AMENDMENTS TO THE DRAWINGS

Please substitute the enclosed sheet, labeled “1/3” and “Replacement Sheet,” for the corresponding sheet originally filed in the application.

FIG. 1

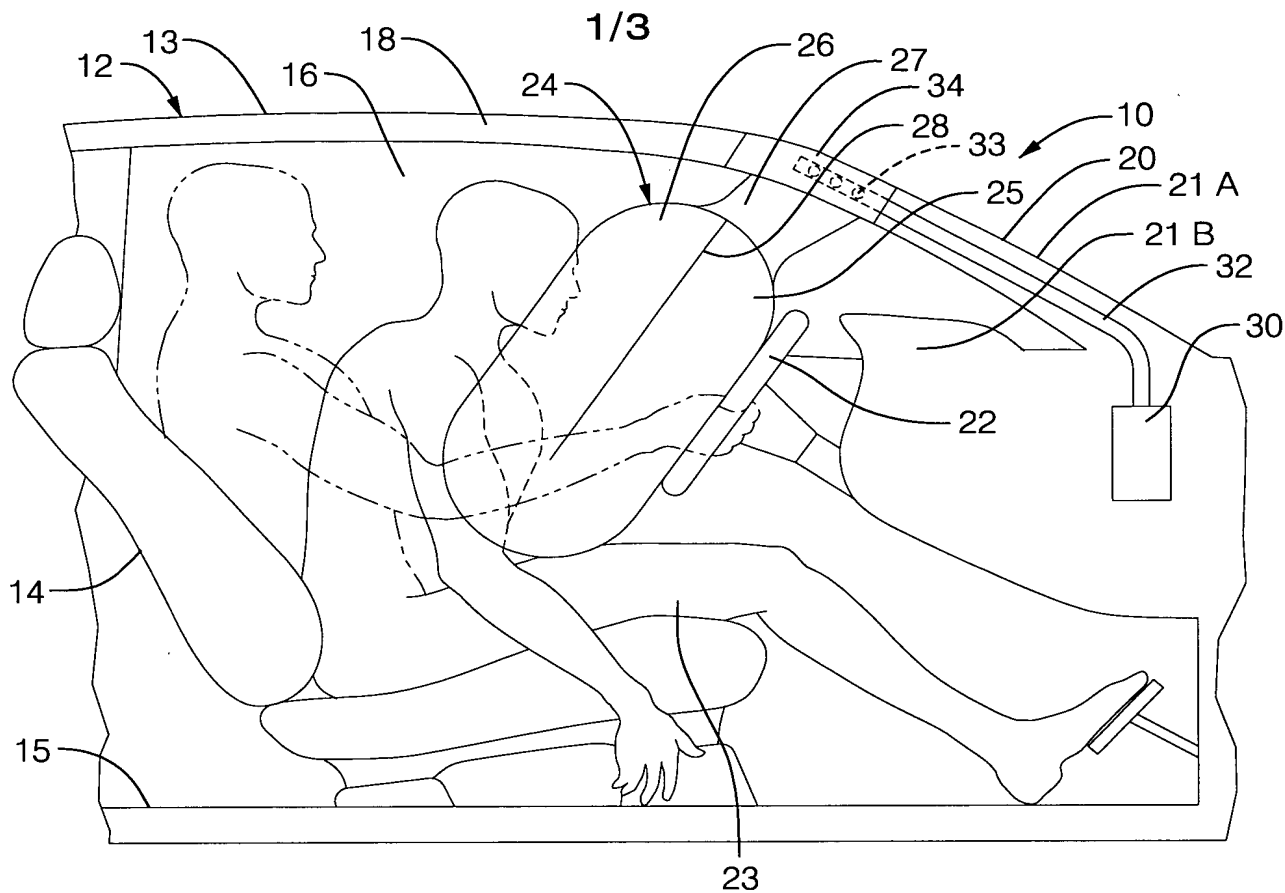
In response to an objection to the drawings in the Office Action, Figs. 1 and 2 have been amended to show diffuser 32 extending under trim molding 34 and including apertures 33, as described at page 9, lines 6-9. Applicants contend that the skilled practitioner would readily understand the diffuser from the description in the specification as filed, and therefore that the amendments to the drawings merely provide clarification without adding new matter to the case.
